# **PRELIMINARY/FINAL DRAINAGE REPORT FOR JUDGE ORR RANCHETTES**

October, 2017

Add PCD File No.  
SP-17-011 &  
SF-17-021

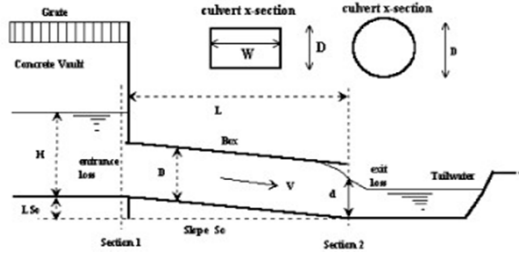
Provide an identifier. Which channel is this associated with?

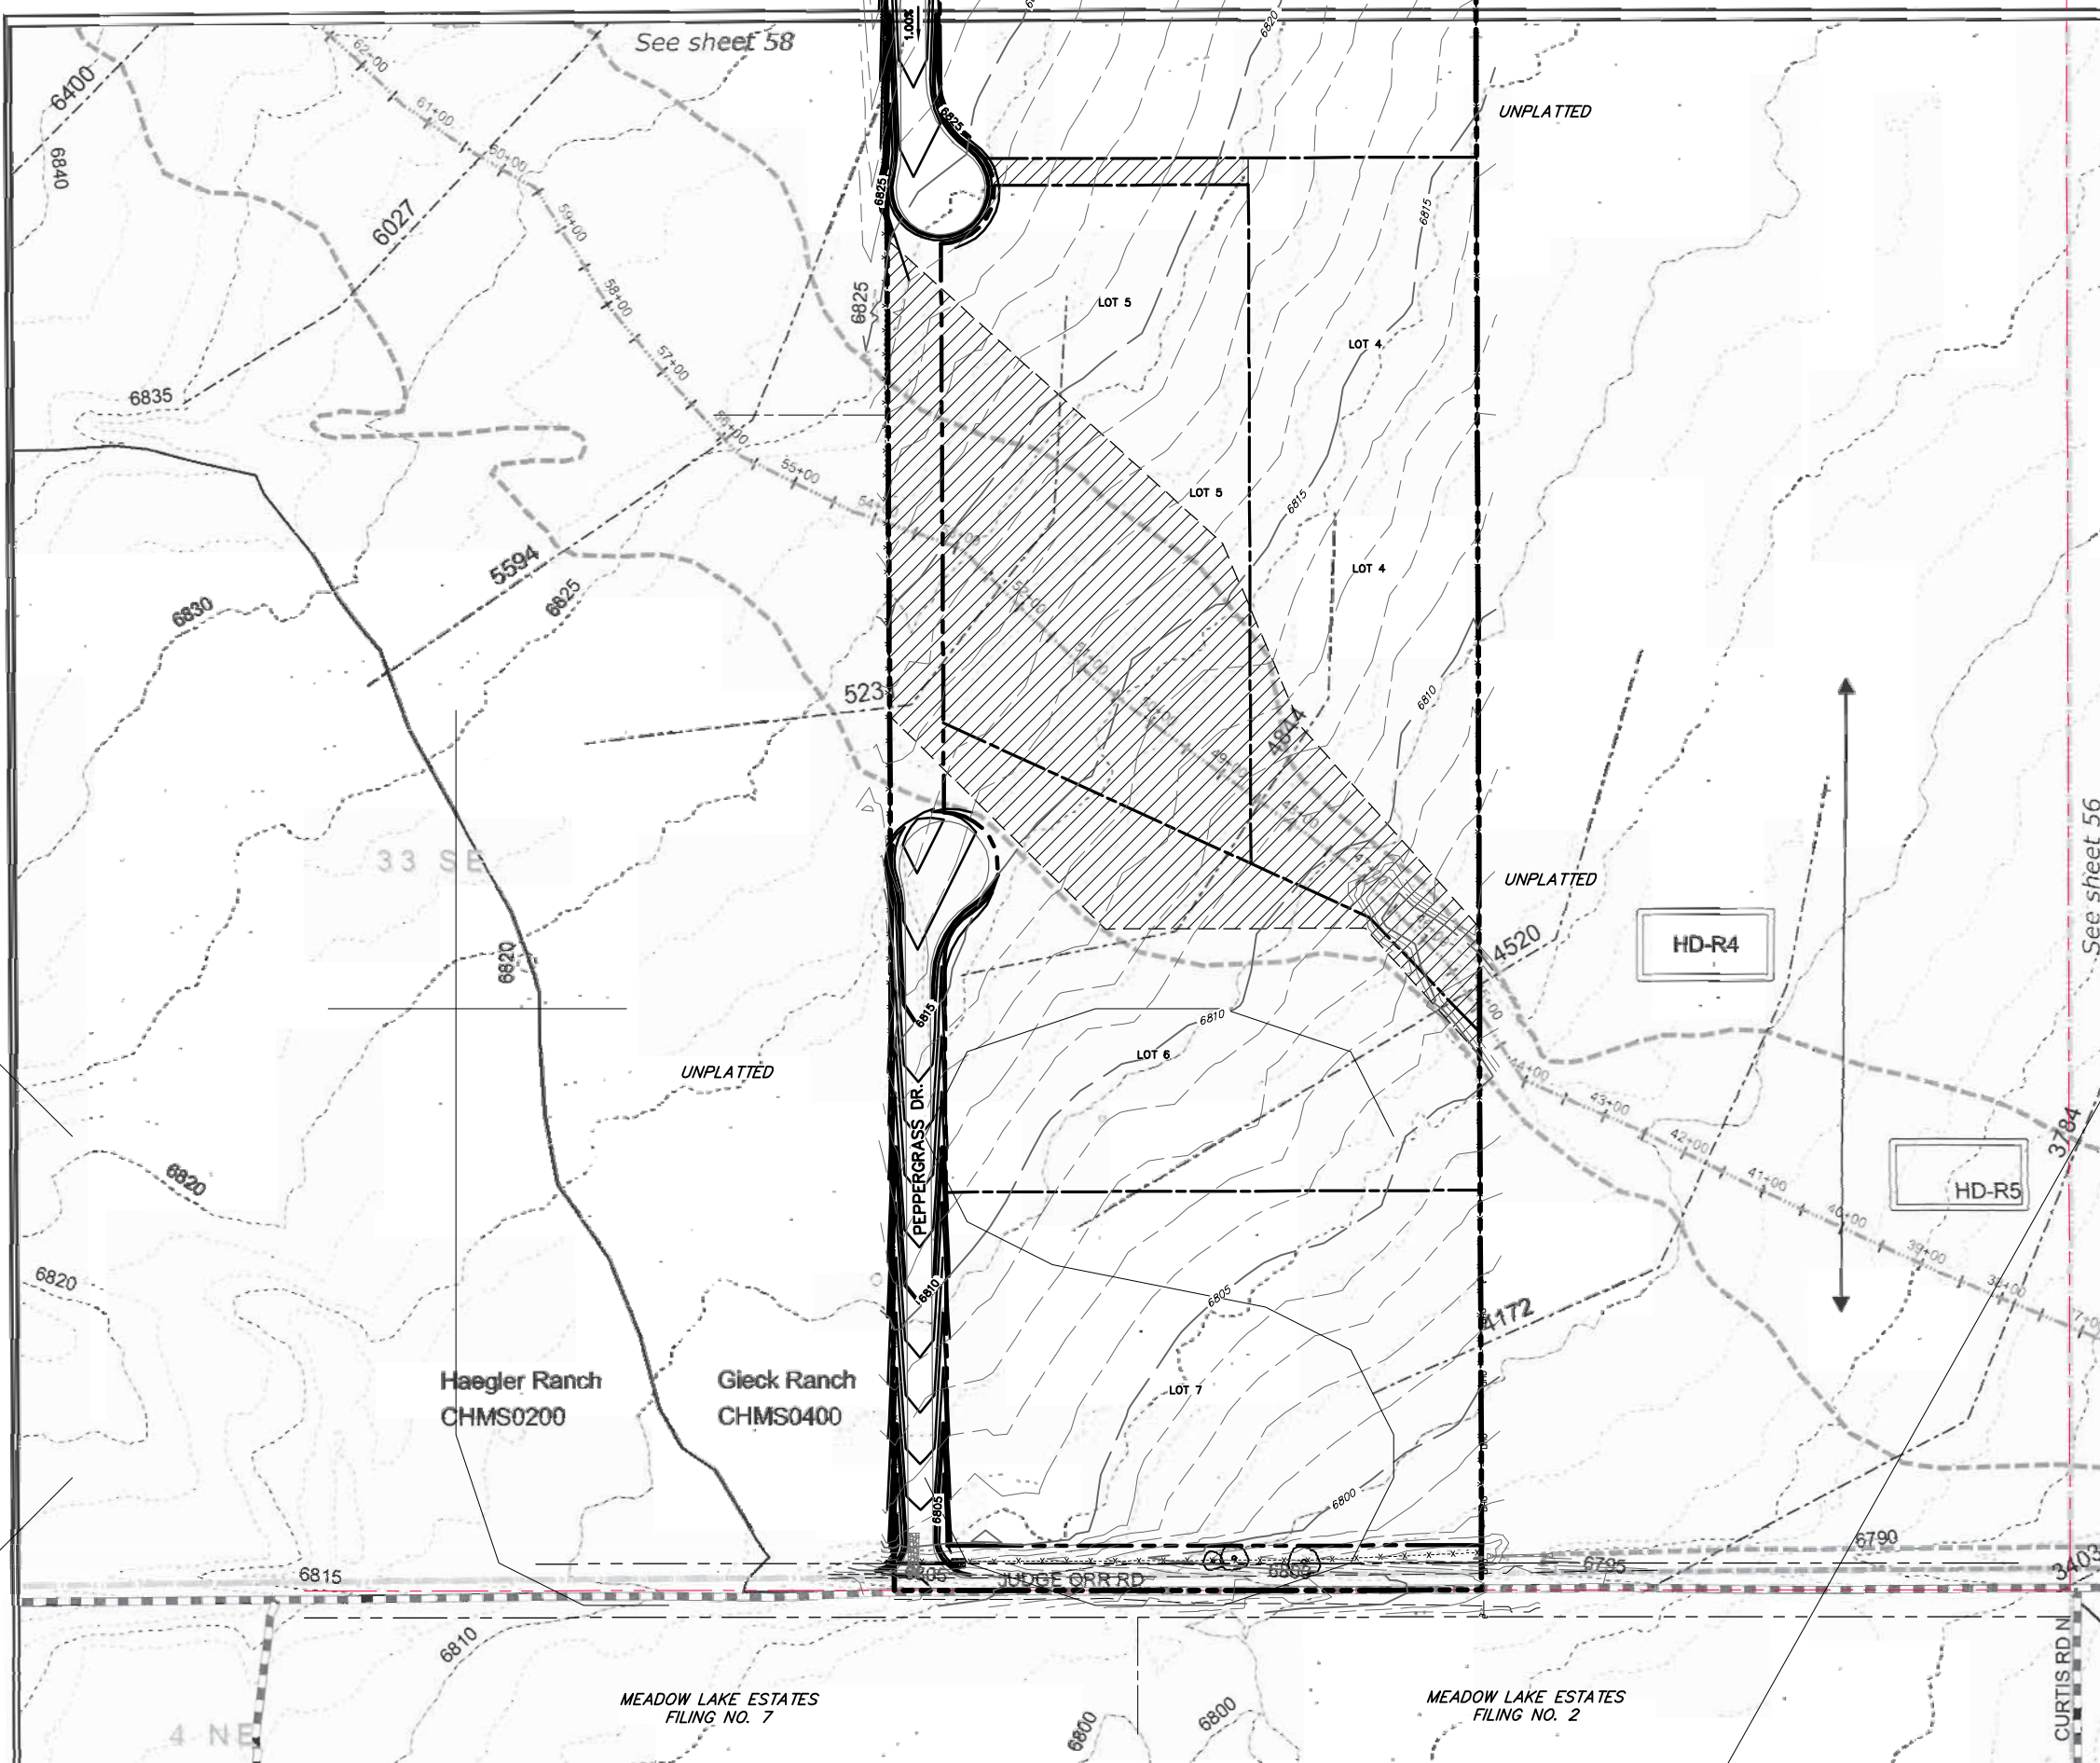
Provide an identifier. Which channel is this associated with?

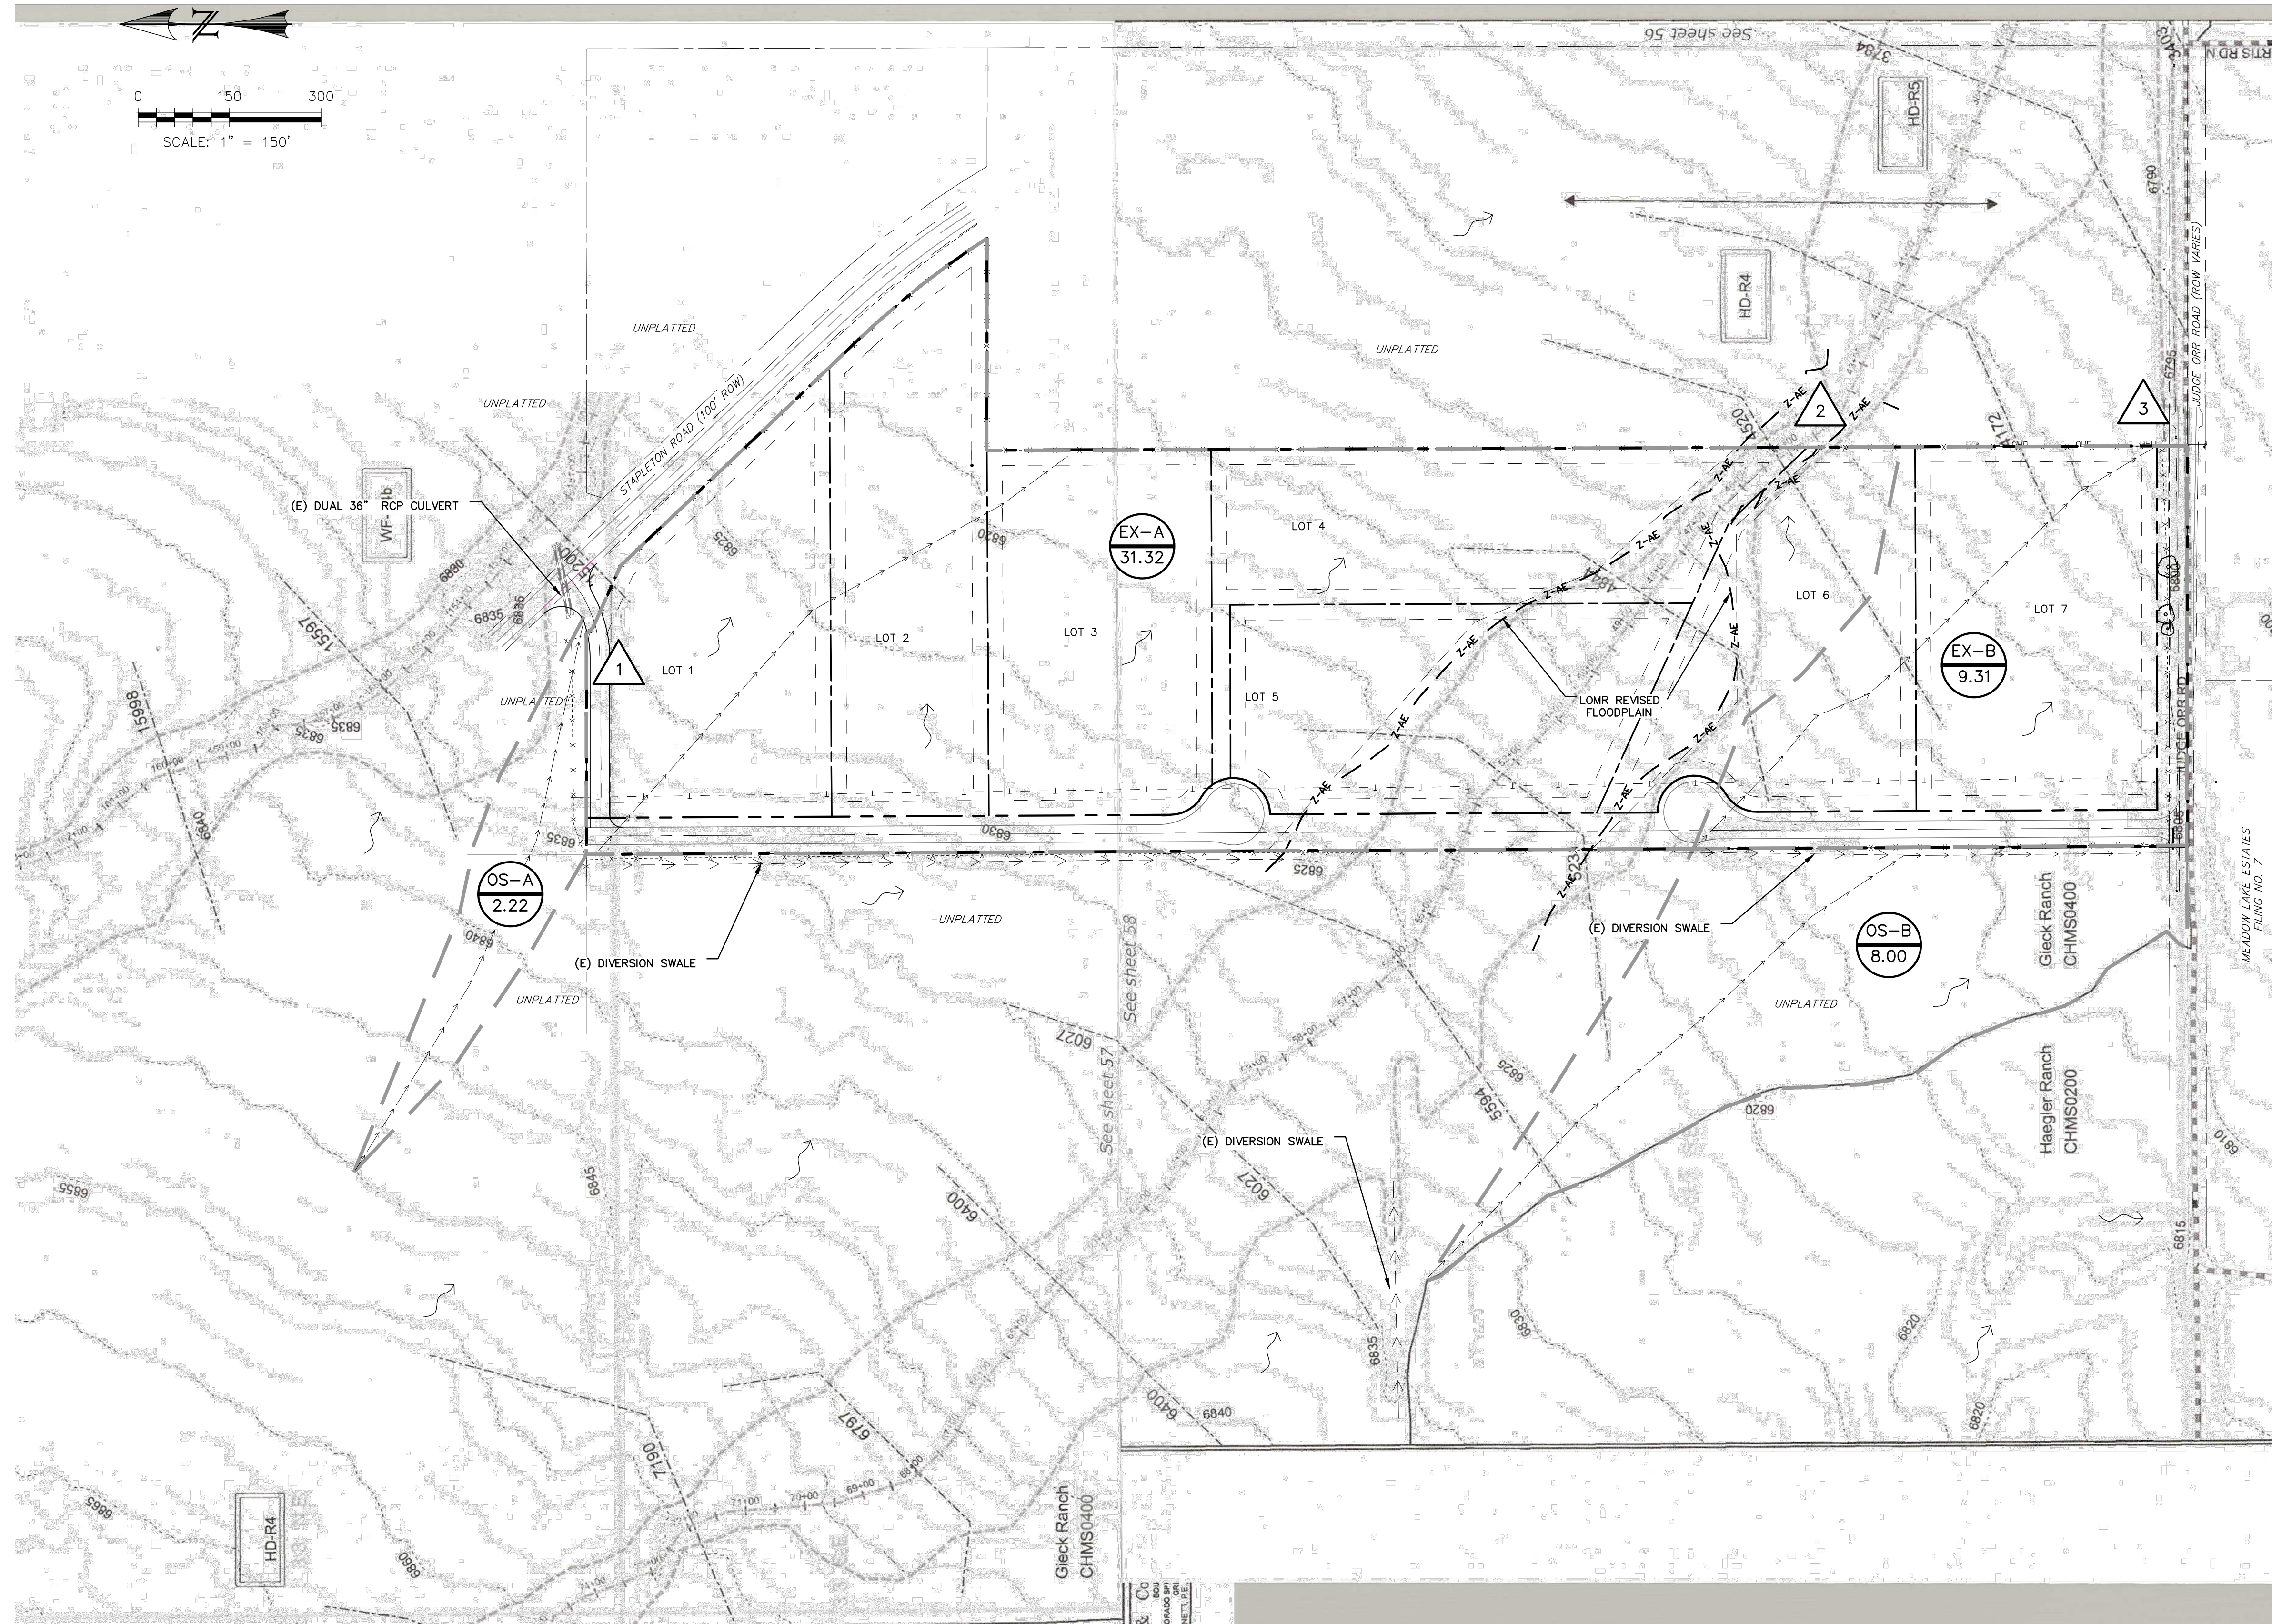
Provide channel analysis through the reach to determine erosion potential (velocity, Froude, shear stress) and provide any erosion control that may be needed.  
 Include a section in the narrative discussing the results of the analysis.
